February 15, 2000

Braidwood Station, Units 1 and 2  
Facility Operating License Nos. NPF-72 and NPF-77  
NRC Docket Nos. STN 50-456 and STN 50-457

Byron Station, Units 1 and 2  
Facility Operating License Nos. NPF-37 and NPF-66  
NRC Docket Nos. STN 50-454 and STN 50-455

Subject: Request for Amendment to Technical Specifications for Byron and Braidwood Stations to Implement the Best Estimate Analyzer for Core Operations Nuclear Power Distribution Monitoring System

Figure 2.7.2 Axial Flux Difference Limits as a Function of Rated Thermal Power

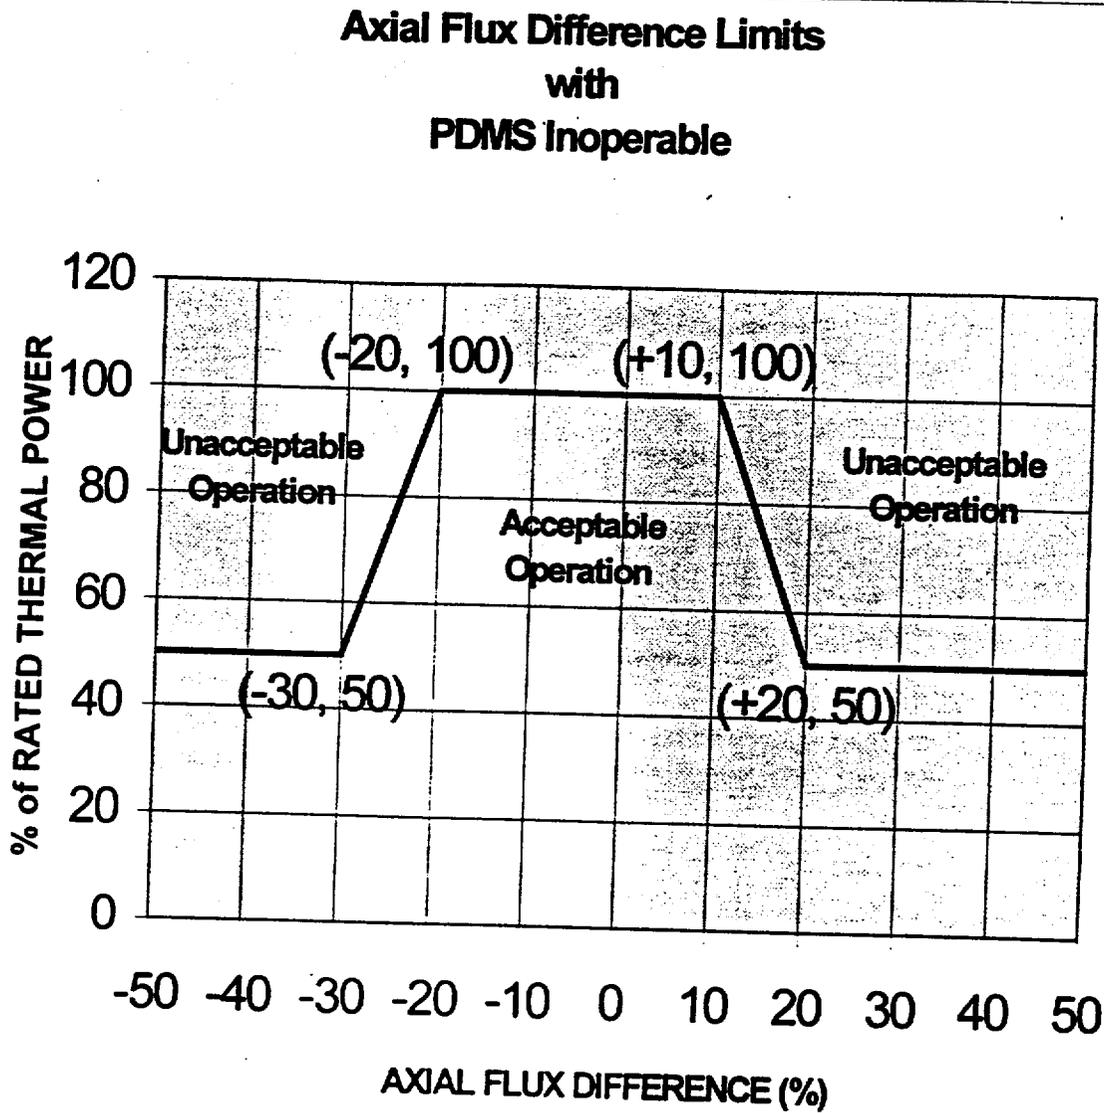
2.7.2 When PDMS is inoperable, the AFD Acceptable Operation Limits are provided in Figure 2.7.2 or the latest valid PDMS Surveillance Report, whichever is more conservative.

Figure 2.7.2 Axial Flux Difference Limits as a Function of Rated Thermal Power

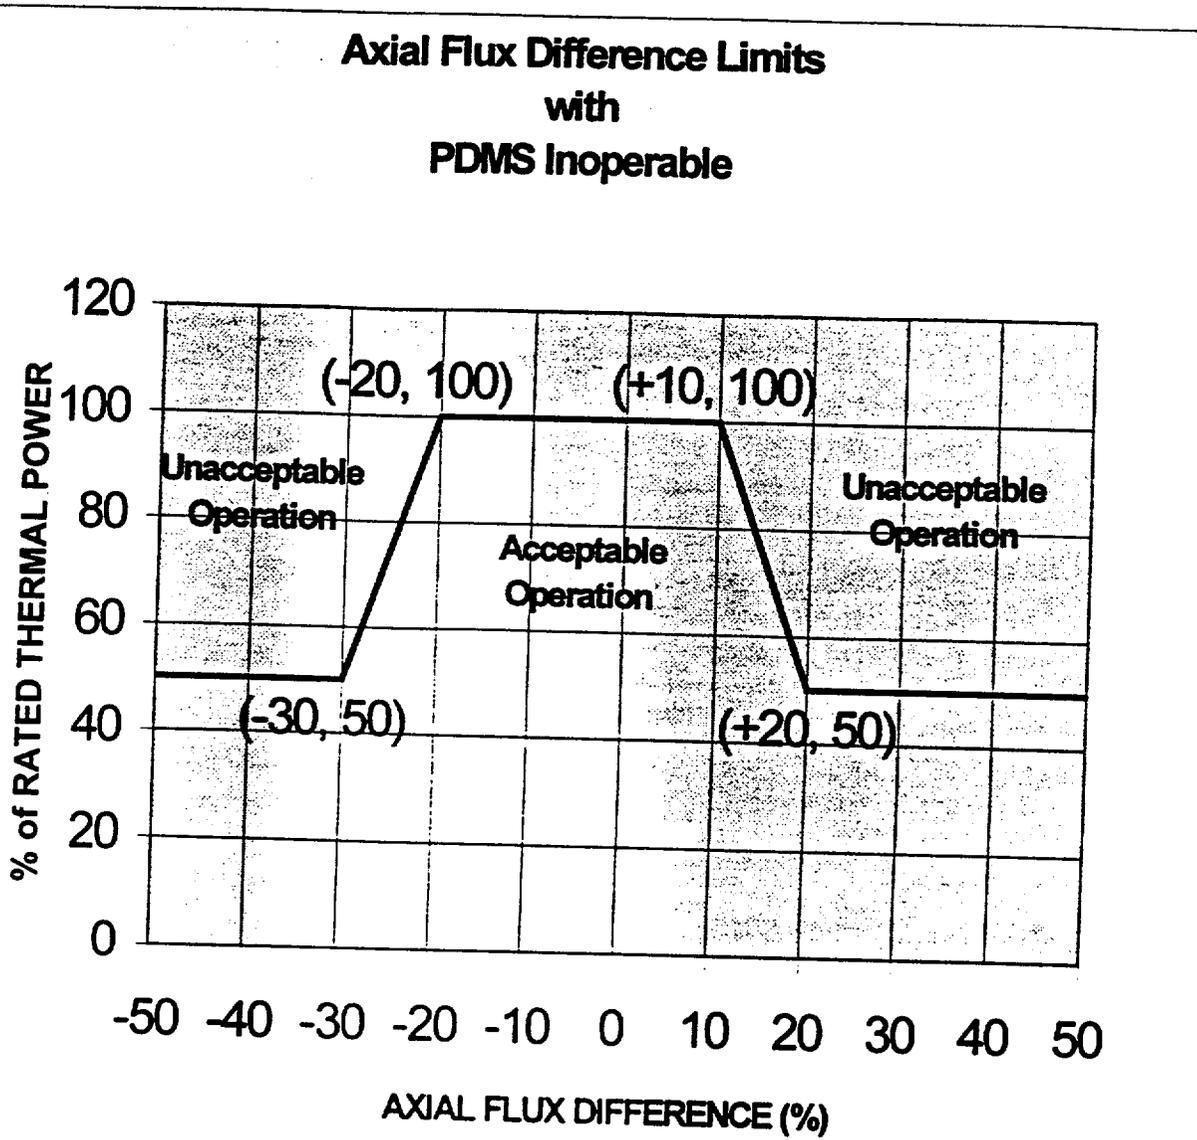
2.7.2 When PDMS is inoperable, the AFD Acceptable Operation Limits are provided in Figure 2.7.2 or the latest valid PDMS Surveillance Report, whichever is more conservative.
